Re: Revised Colusa Subbasin Groundwater Sustainability Plan

AquAlliance, the California Sportfishing Protection Alliance, and the California Water Impact Network (hereinafter AquAlliance) submit the following comments and questions on the Revised Colusa Subbasin Groundwater Sustainability Plan (“Revised GSP” or “Plan”) to the Colusa Groundwater Authority and the Glenn Groundwater Authority GSAs (“GSAs”).

Figure 1. Subsidence in Agricultural Lands Within the Colusa Subbasin

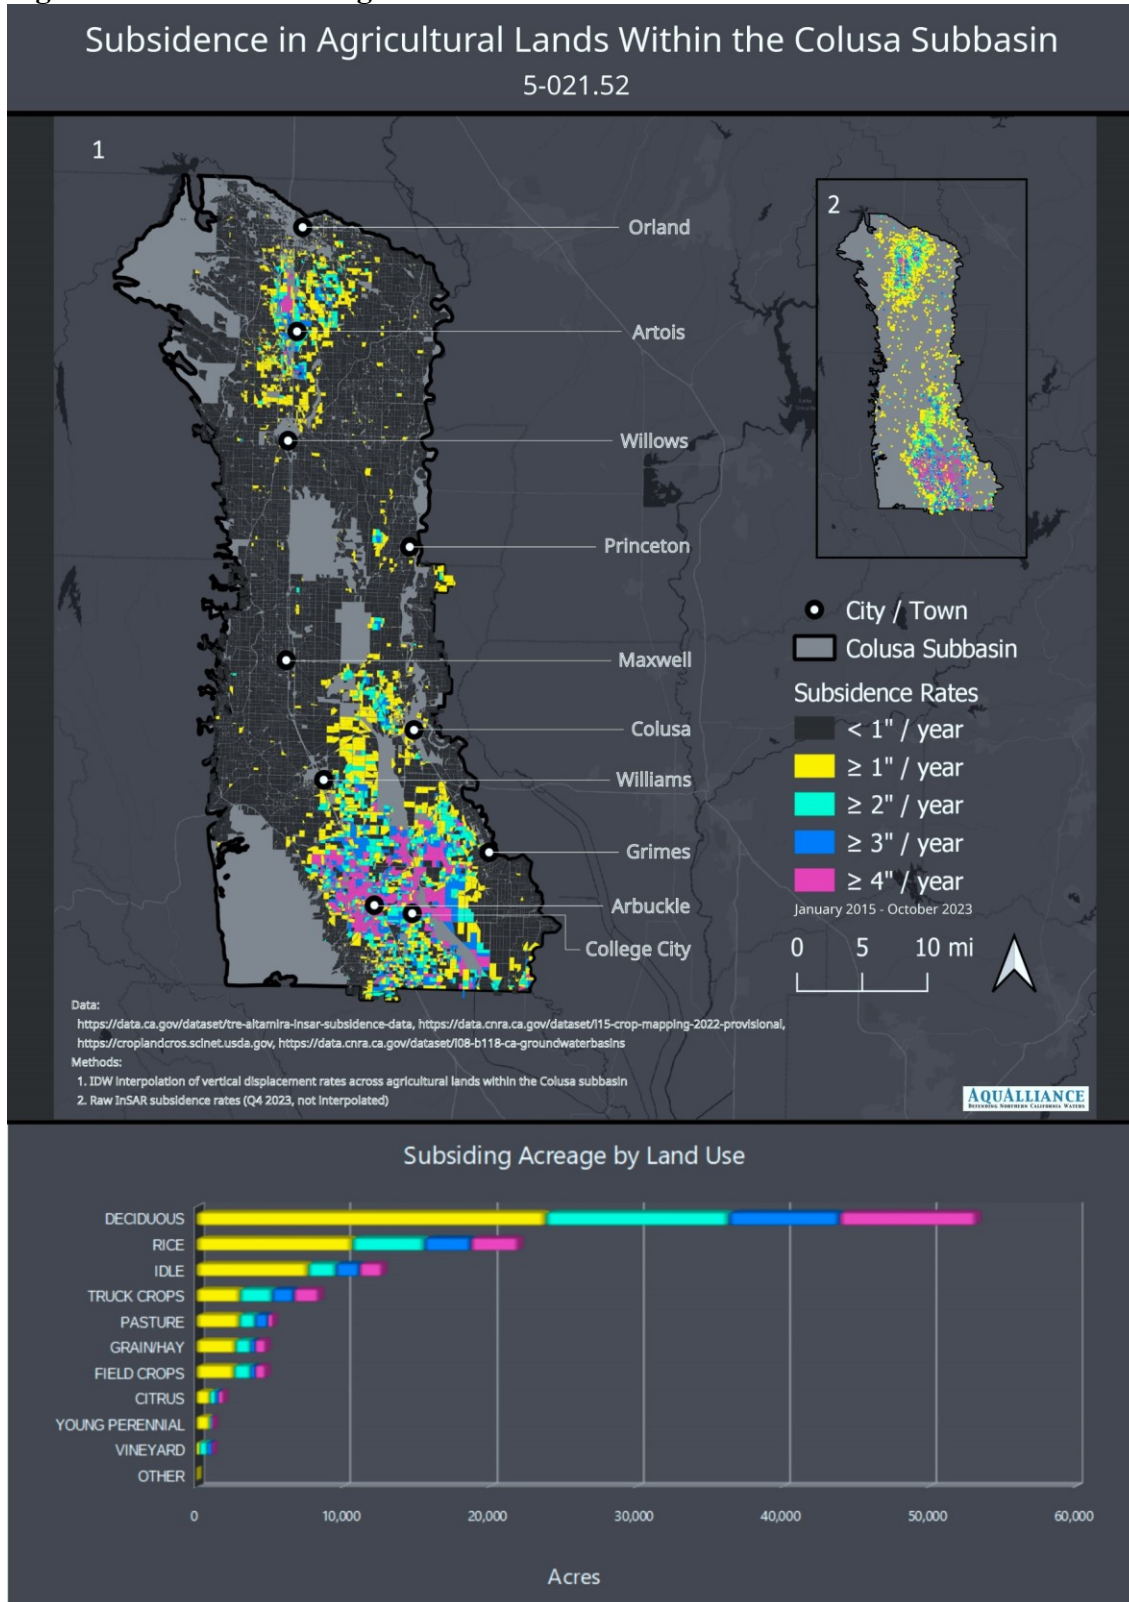
b) Figure 1 clearly illustrates the subsidence in the Colusa Subbasin. How does it compare with the GSP material? As one can see in the magenta areas, the land is collapsing at 4 inches per year, or a foot every three years. Knowing the land uses overlying the subsidence paints an interesting picture. What will the GSAs consider doing to stop the actors causing it?

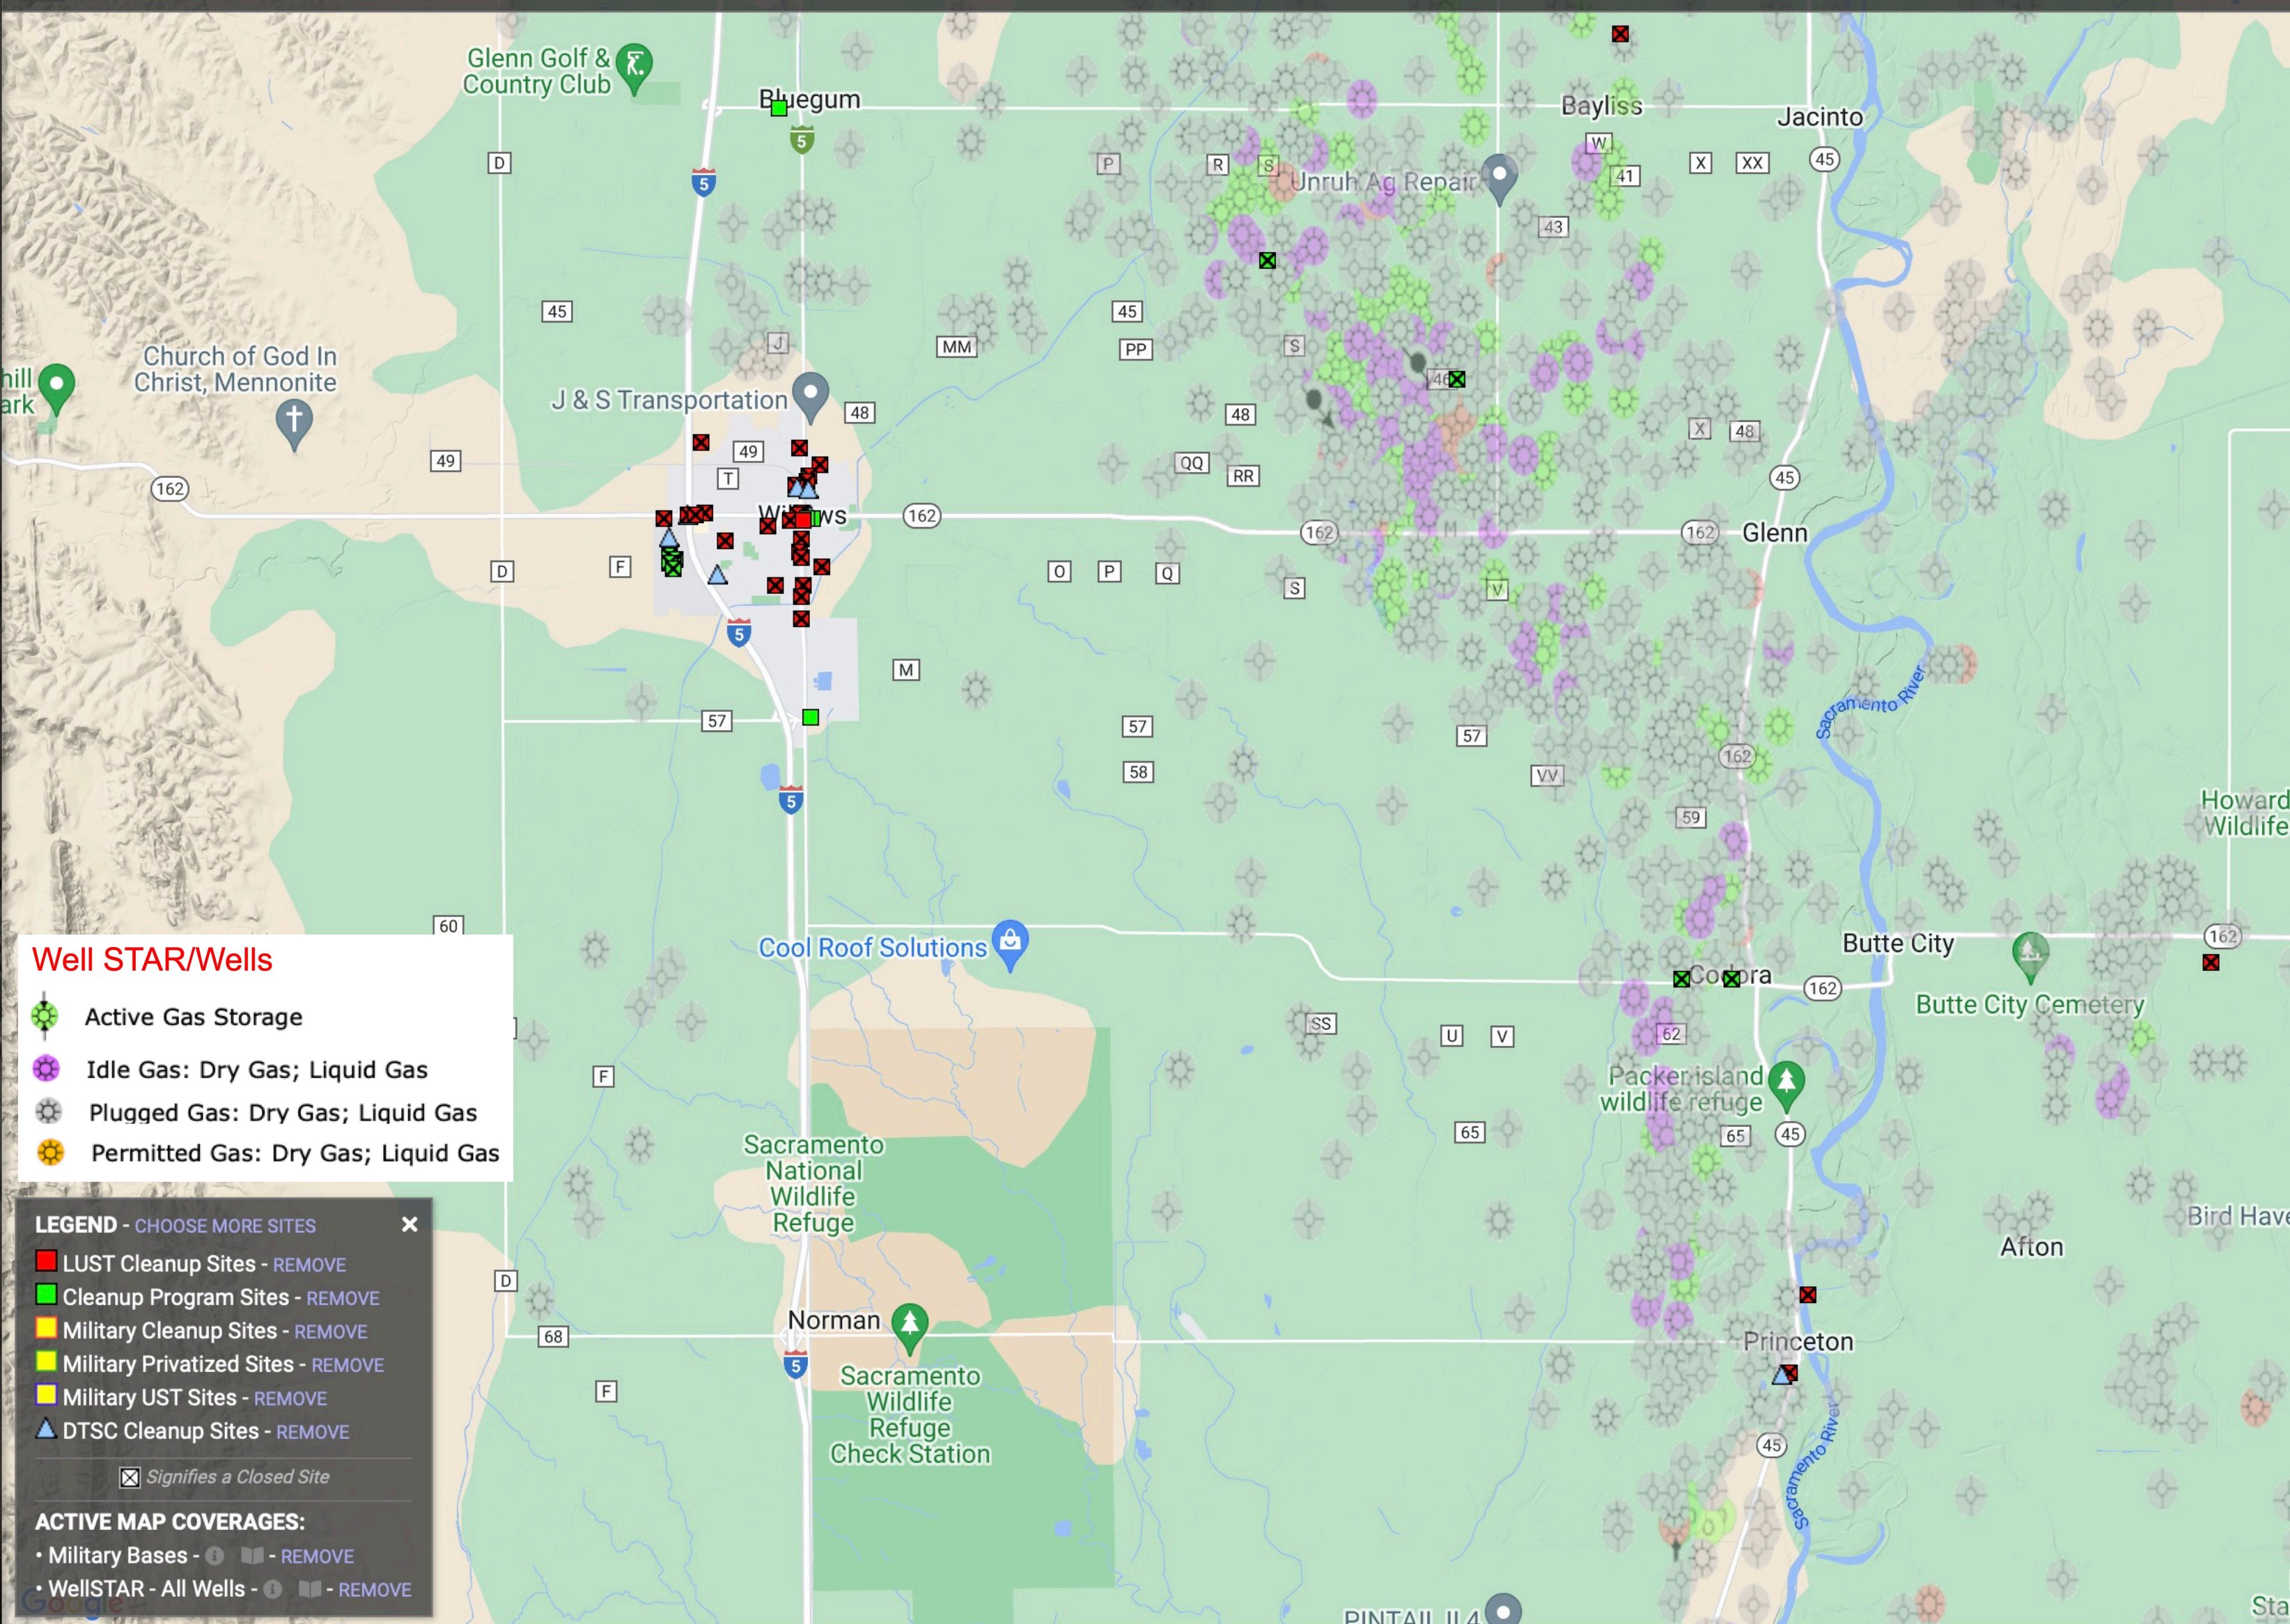
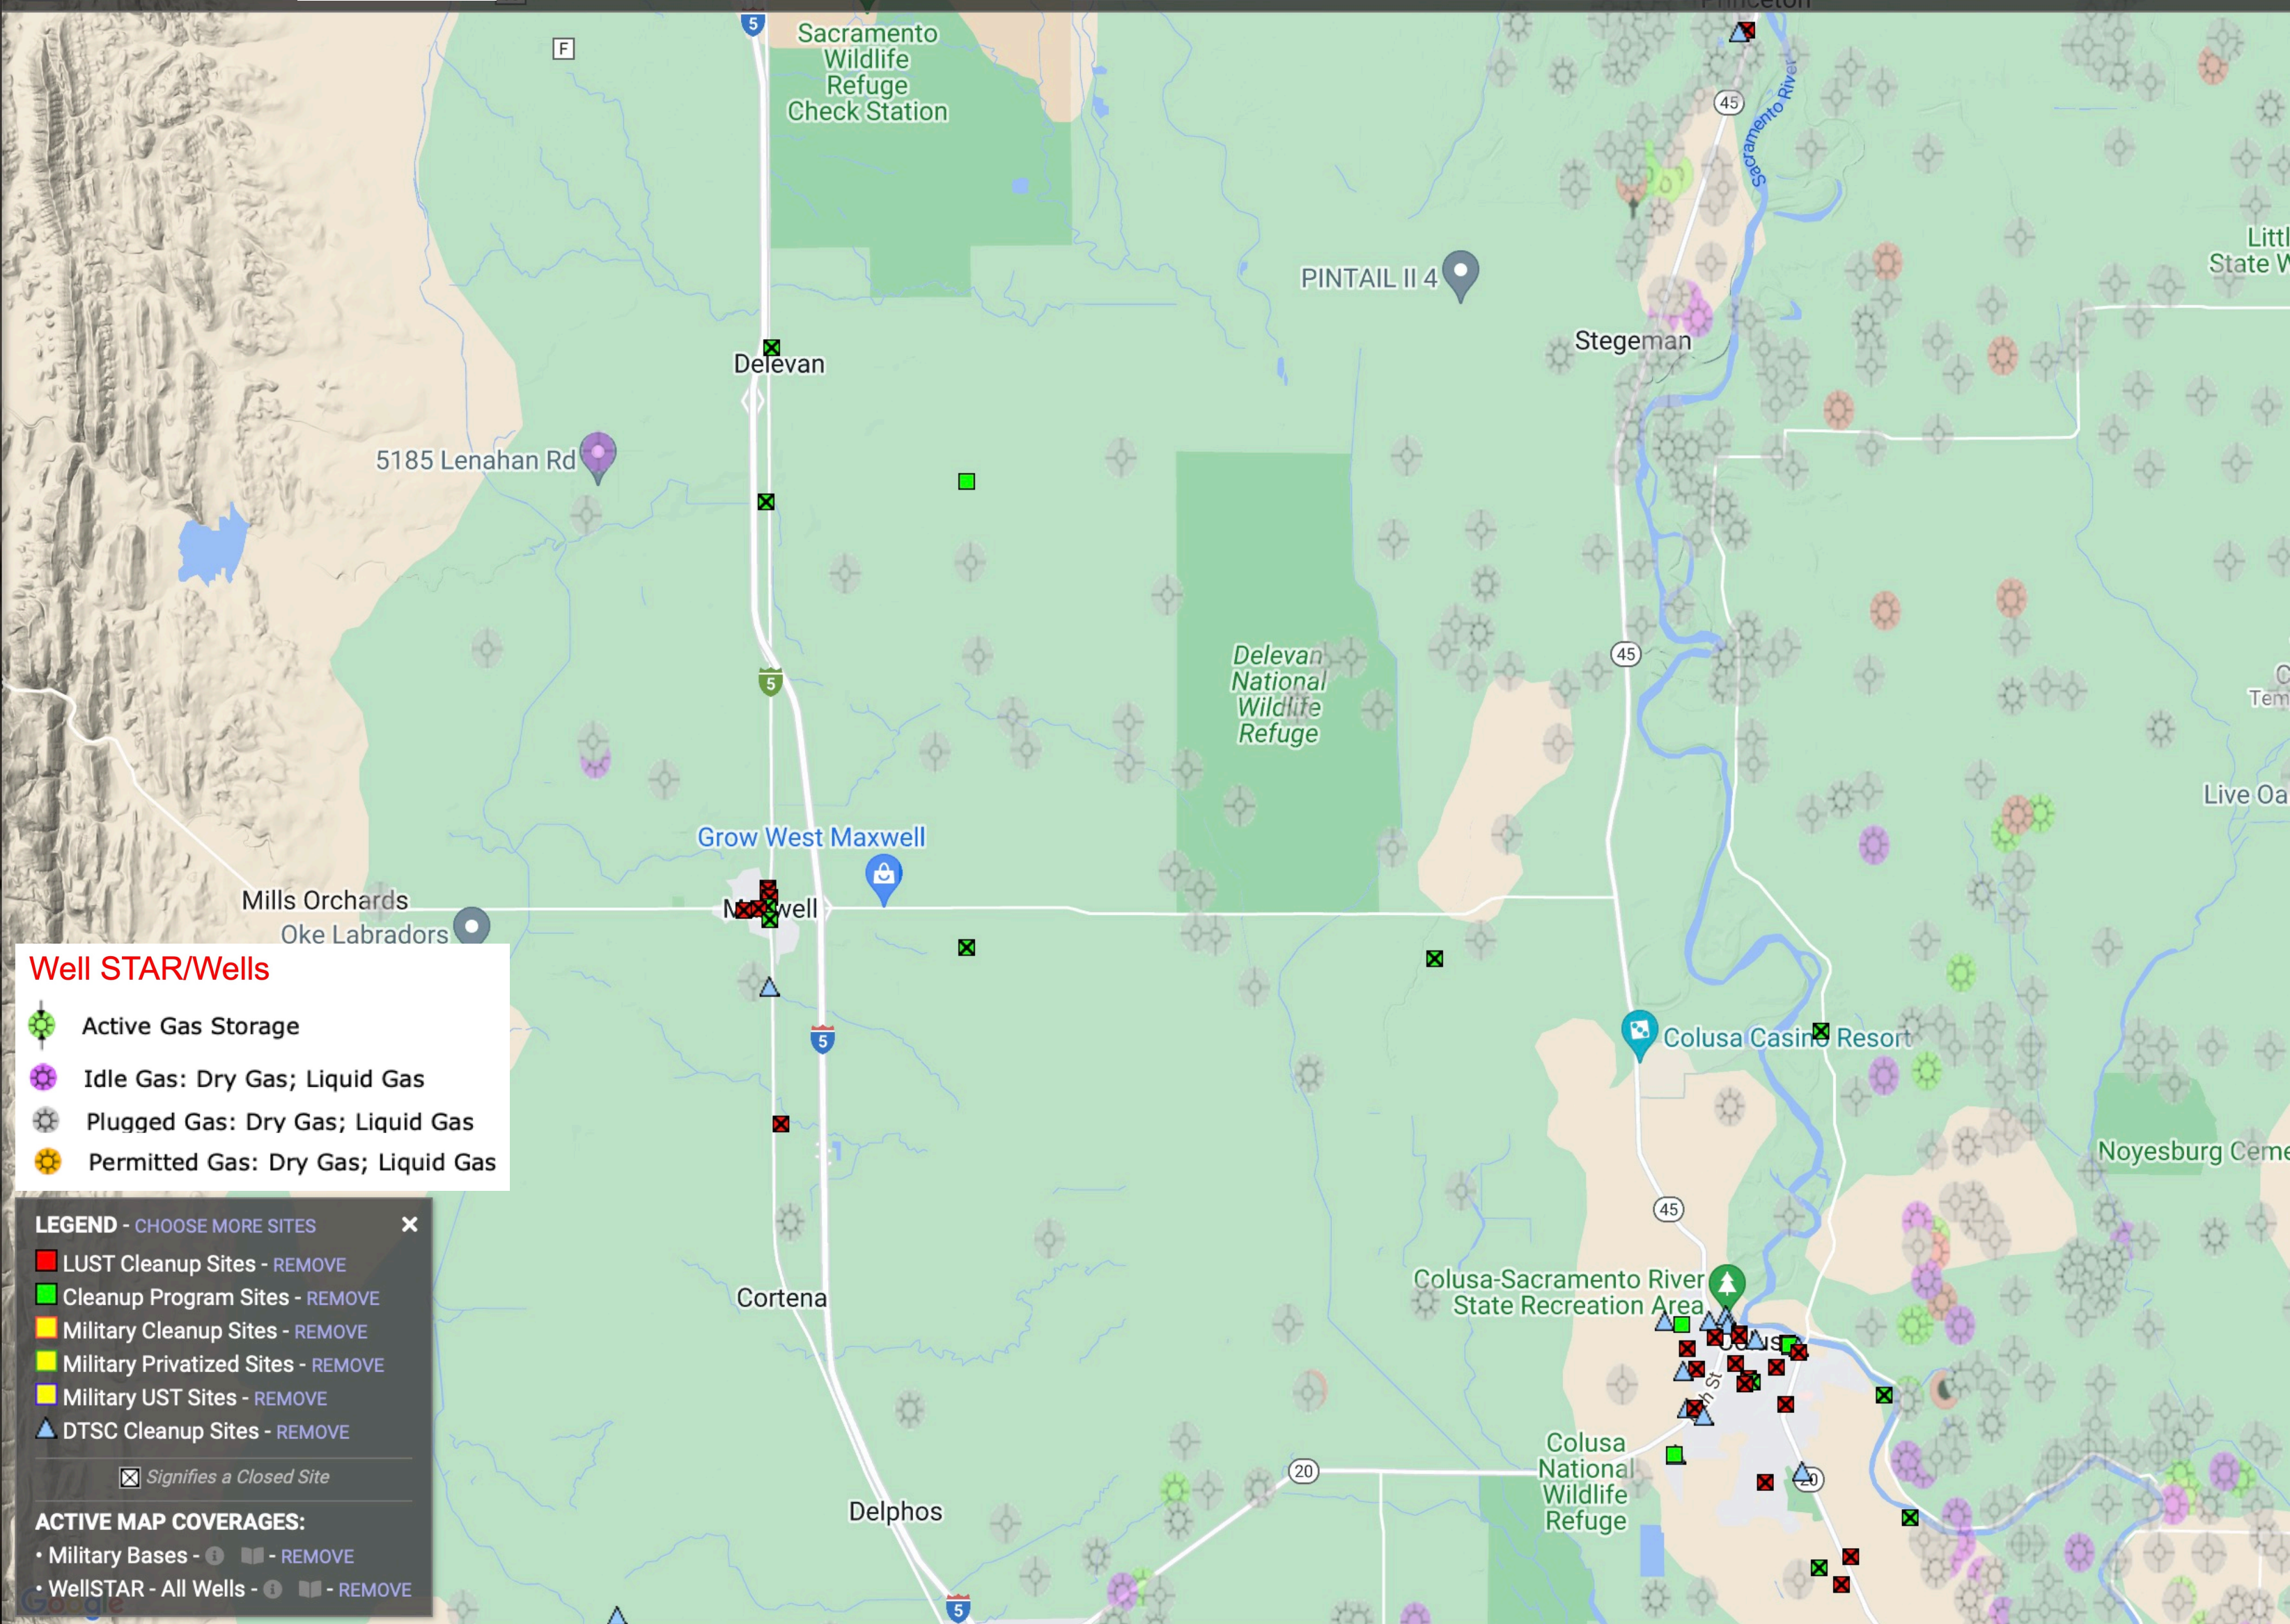
The attached six screen captures of the Geotracker website show that there are a number of known contaminated sites and oil and gas wells throughout the Subbasin. The Revised GSP doesn't provide an analysis of whether the monitoring network shown in Figure 4-3 is adequate to collect sufficient data to demonstrate short-term, seasonal, and long-term trends in groundwater for known contaminants for each applicable principal aquifer to determine groundwater quality trends for water quality indicators to address known water quality issues (CCR § 354.34(a), (c)(4)).
